DUKE POWER COMPANY

OCONEE NUCLEAR STATION, UNIT NO. 1

AMENDMENT TO FACILITY OPERATING LICENSE

Amendment No. 45
License No. DPR-38

Figure 2.1-1B

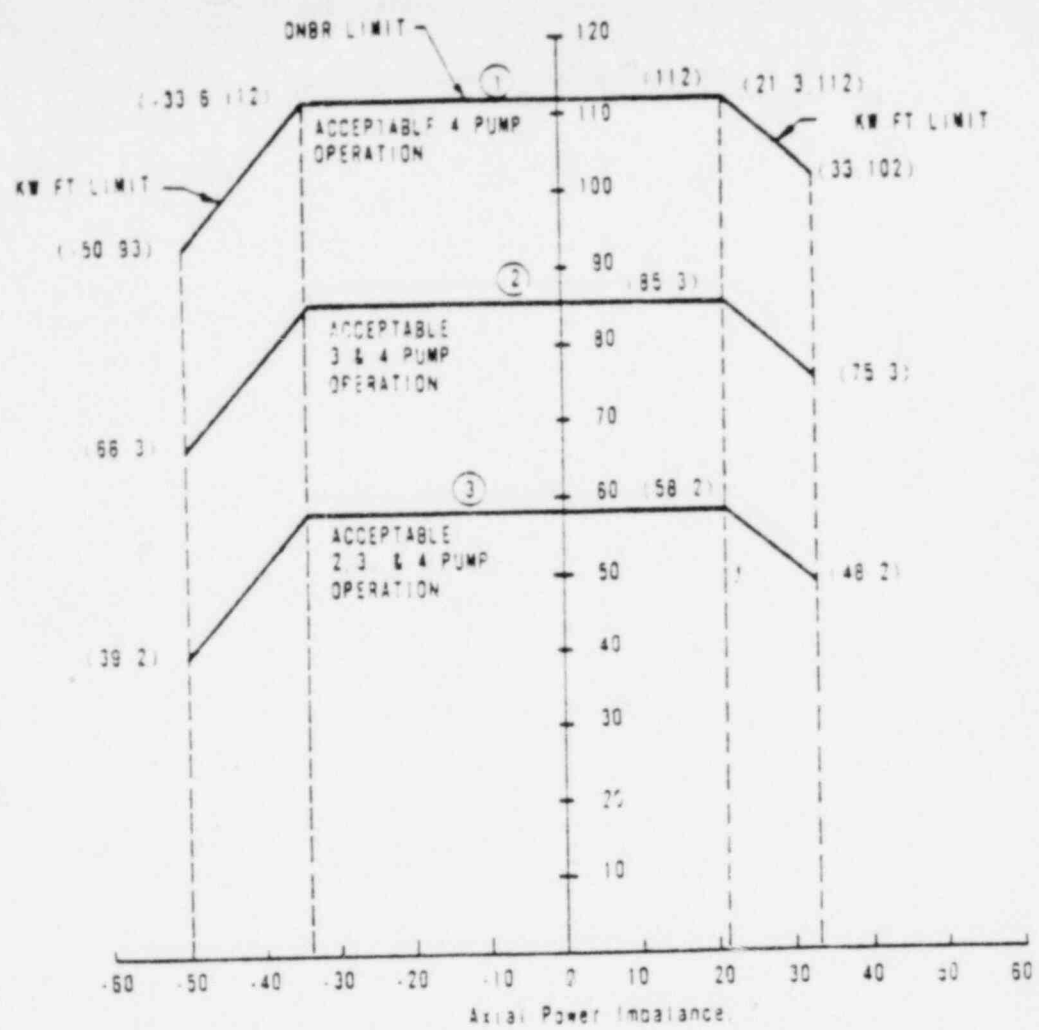
The curve presented in Figure 2.1-1B represents the conditions at which a minimum DNBR of 1.30 is predicted for the maximum possible thermal power (112 percent) when four reactor coolant pumps are operating (minimum reactor coolant flow is 374,880 gpm). This curve is based on the following nuclear power peaking factors with potential fuel densitication and fuel rod bowing effects:

$F_q^N = 2.67$; $F_{\Delta H}^N = 1.78$; $F_z^N = 1.50$. The design peaking combination results in a more conservative DNBR than any other power shape that exists during normal operation.

OCONEE NUCLEAR STATION
Figure 2.3-2B

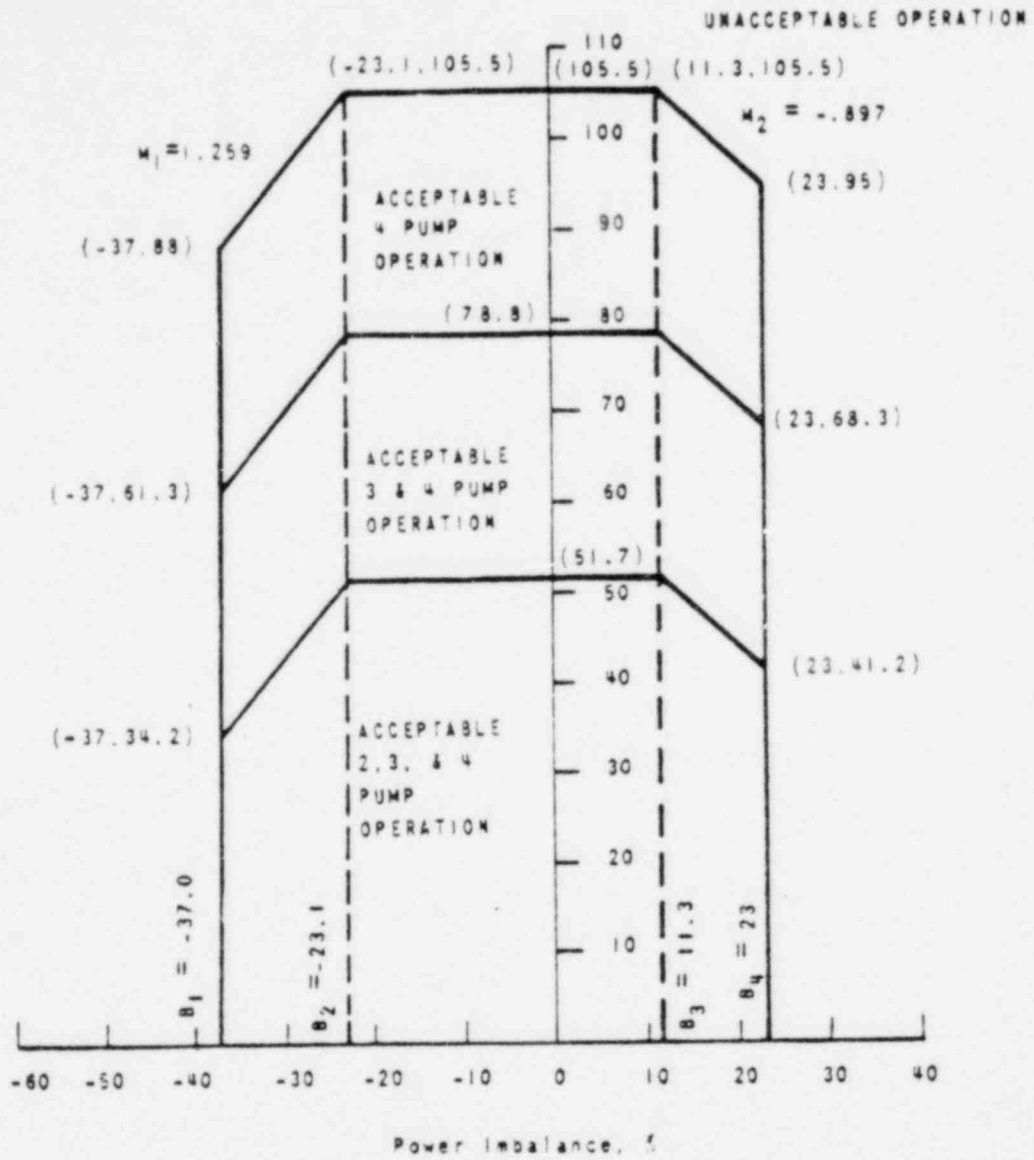
During a startup accident from low power or a slow rod withdrawal from high power, the system high pressure set point is reached before the nuclear over-power trip set point. The trip setting limit shown in Figure 2.3-1A - Unit 1

2.3-1B - Unit 2

for high reactor coolant system pressure (2355 psig) has been established to maintain the system pressure below the safety limit (2750 psig) for any design transient. (1)

Figure 3.5.2-1B1

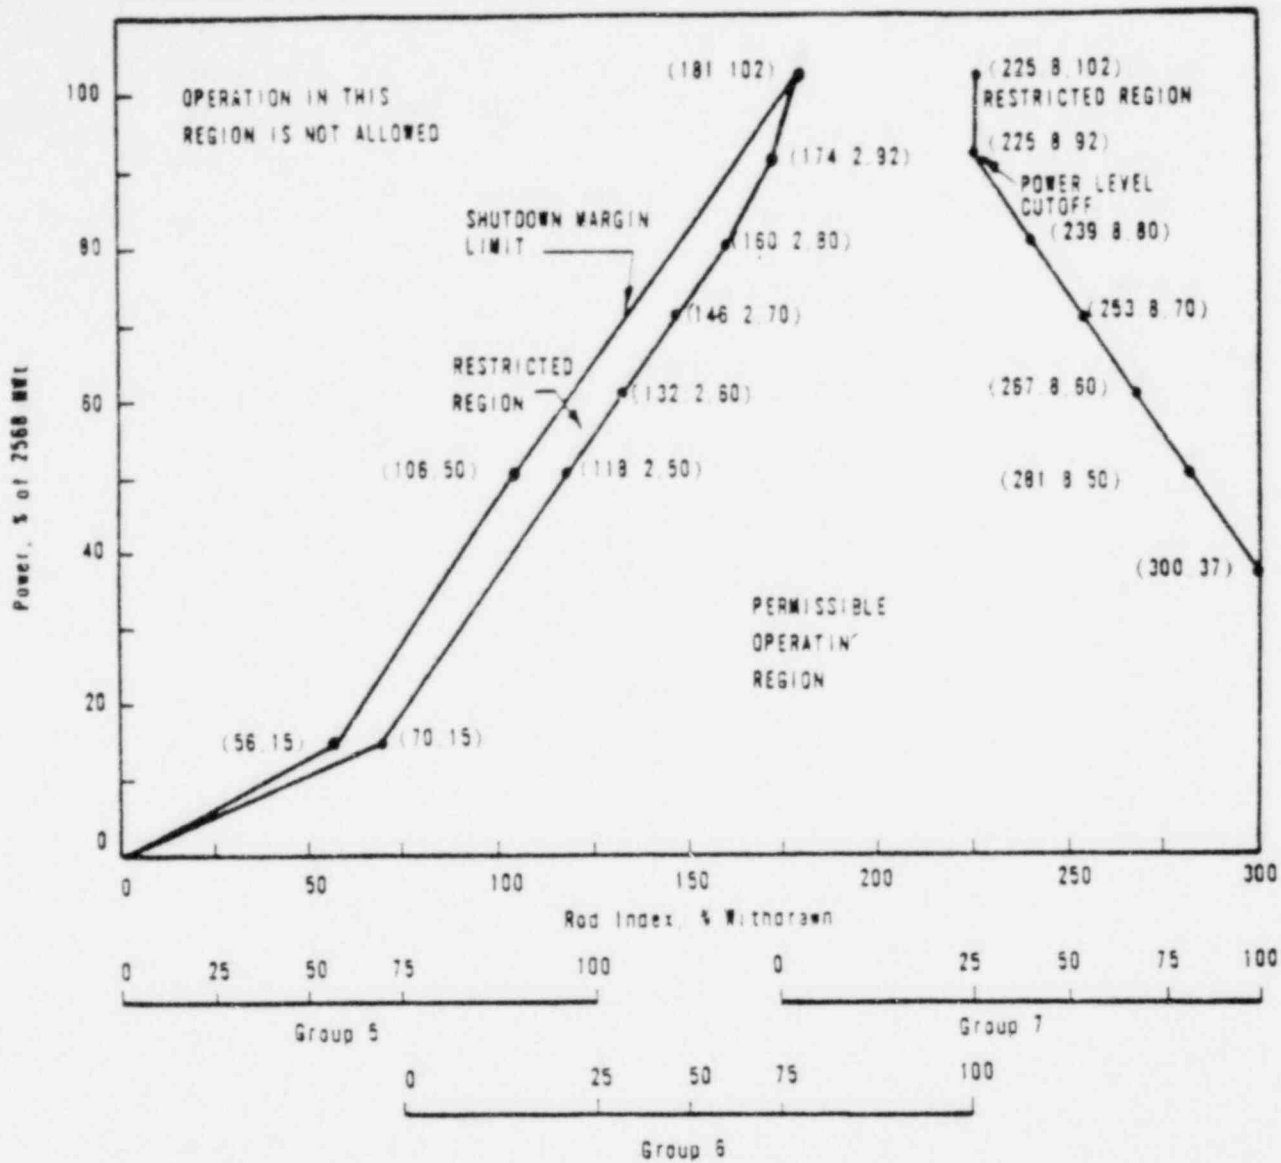
- c. Position limits are specified for regulating and axial power shaping control rods. Except for physics tests or exercising control rods, the regulating control rod insertion/withdrawal limits are specified on figures 3.5.2-1A1 and 3.5.2-1A2 (Unit 1); 3.5.2-1B1, 3.5.2-1B2 and 3.5.2-1B3 (Unit 2); 3.5.2-1C1, 3.5.2-1C2 and 3.5.2-1C3 (Unit 3) for four pump operation, and on figures 3.5.2-2A1 and 3.5.2-2A2 (Unit 1); 3.5.2-2B1 3.5.2-2B2 and 3.5.2-2B3 (Unit 2); 3.5.2-2C1, 3.5.2-2C2 and 3.5.2-2C3 (Unit 3) for two or three

Figure 3.5.2-382

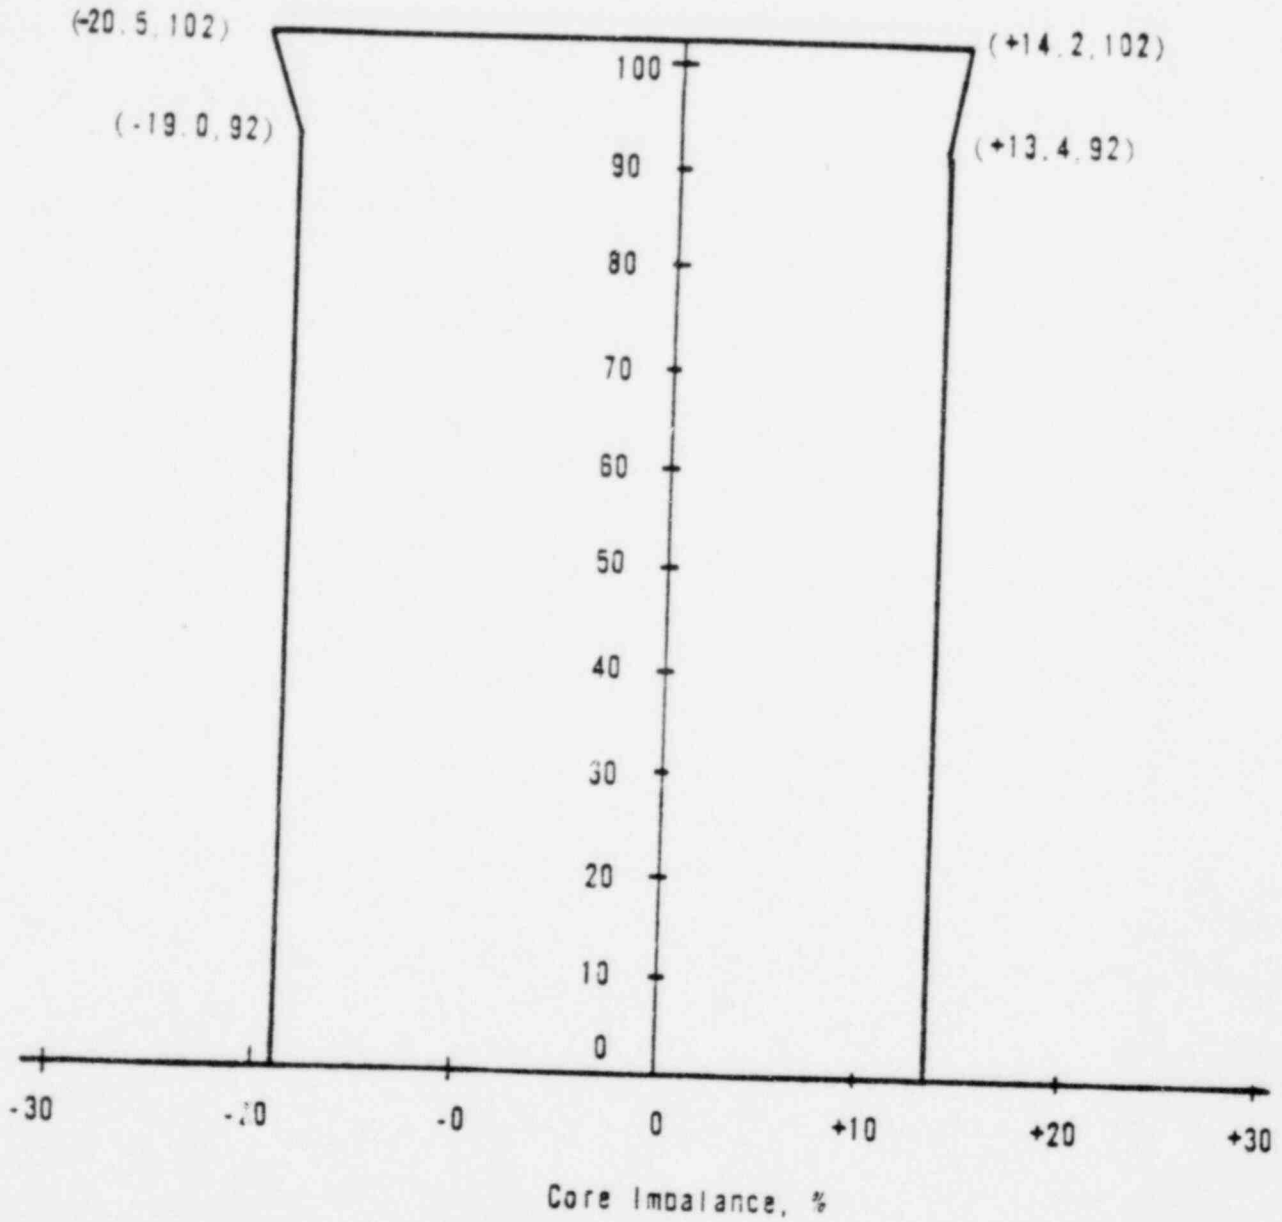
3.5.2.6 Reactor power imbalance shall be monitored on a frequency not to exceed two hours during power operation above 40 percent rated power. Except for physics tests, imbalance shall be maintained within the envelope defined by Figures 3.5.2-3A1, 3.5.2-3A2, 3.5.3-3B1, 3.5.2-3B2, 3.5.2-3B3, 3.5.2-3C1, 3.5.2-3C2, and 3.5.2-3C3. If the imbalance is not within the envelope defined by these figures, corrective measures shall be taken to achieve an acceptable imbalance. If an acceptable imbalance is not achieved within two hours, reactor power shall be reduced until imbalance limits are met.

The power-imbalance envelope defined in Figures 3.5.2-3A1, 3.5.2-3A2, 3.5.2-3B1, 3.5.2-3B2, 3.5.2-3B3, 3.5.2-3C1, 3.5.2-3C2 and 3.5.2-3C3 is based on LOCA analyses which have defined the maximum linear heat rate (see Figure 3.5.2-5) such that the maximum clad temperature will not exceed the Final Acceptance Criteria. Corrective measures will be taken immediately should the indicated quadrant tilt, rod position, or imbalance be outside their specified boundary. Operation in a situation that would cause the Final Acceptance Criteria to be approached should a LOCA occur is highly improbable because all of the power distribution parameters (quadrant tilt, rod position, and imbalance) must be at their limits while simultaneously all other engineering and uncertainty factors are also at their limits.** Conservatism is introduced by application of:

Figure 3.5.2-4B1

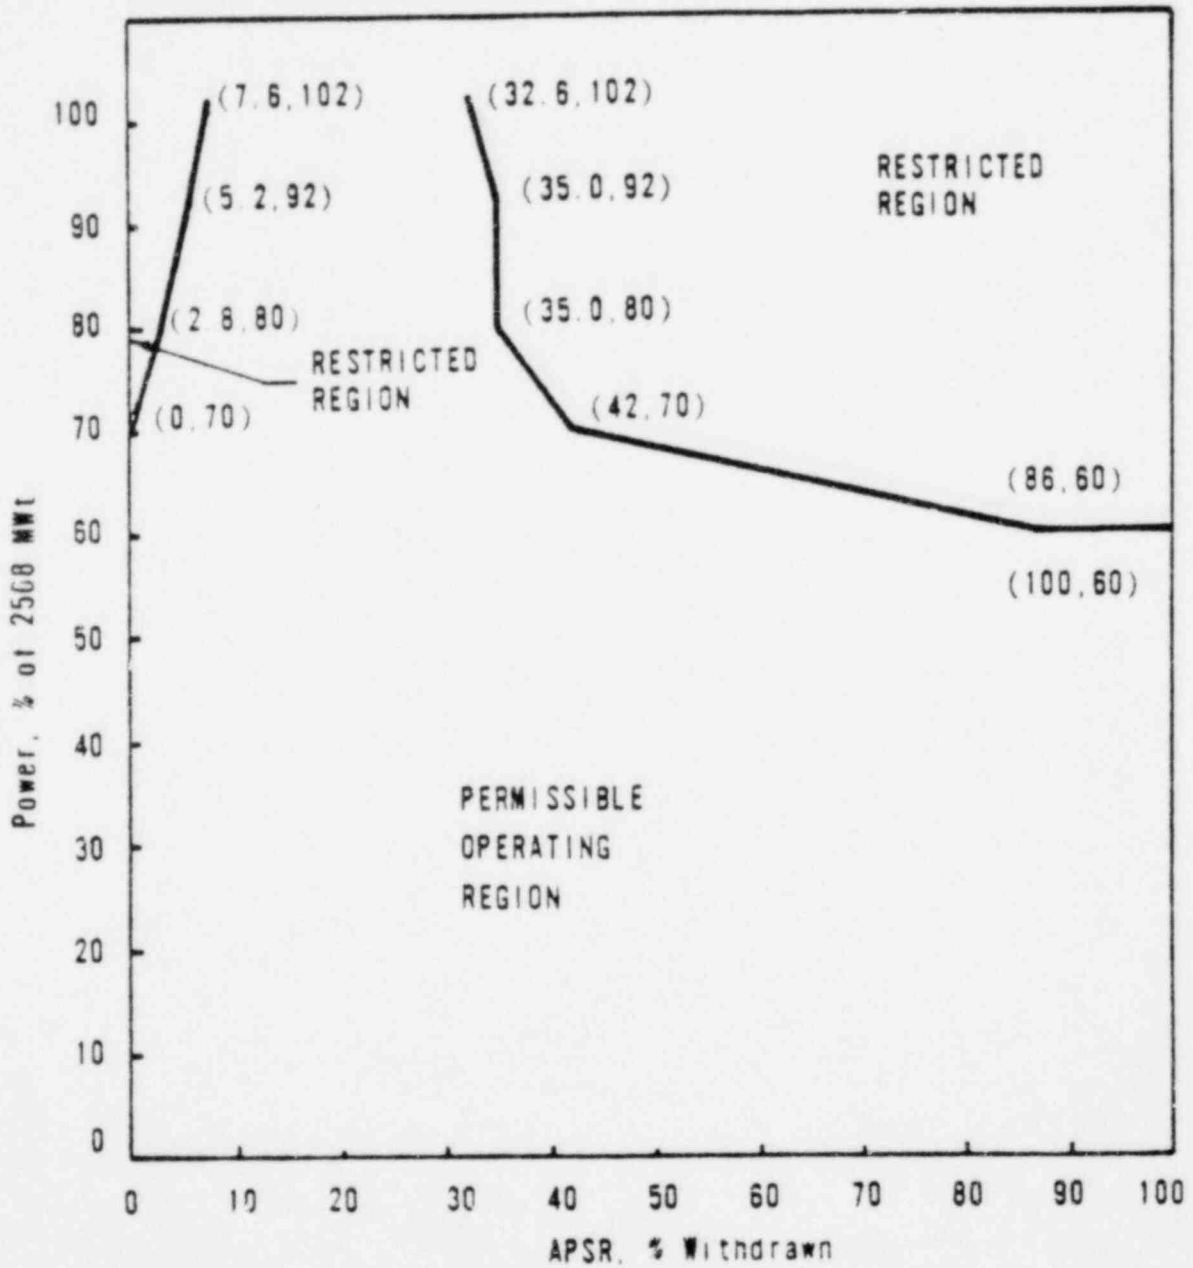
pump operation. Also, excepting physics tests or exercising control rods, the axial power shaping control rod insertion/withdrawal limits are specified on figures 3.5.2-4B1, 3.5.2-4B2, and 3.5.2-4B3 (Unit 2). If the control rod position limits are exceeded, corrective measures shall be taken immediately to achieve an acceptable control rod position. An acceptable control rod position shall then be attained within two hours. The minimum shutdown margin required by Specification 3.5.2.1 shall be maintained at all times.
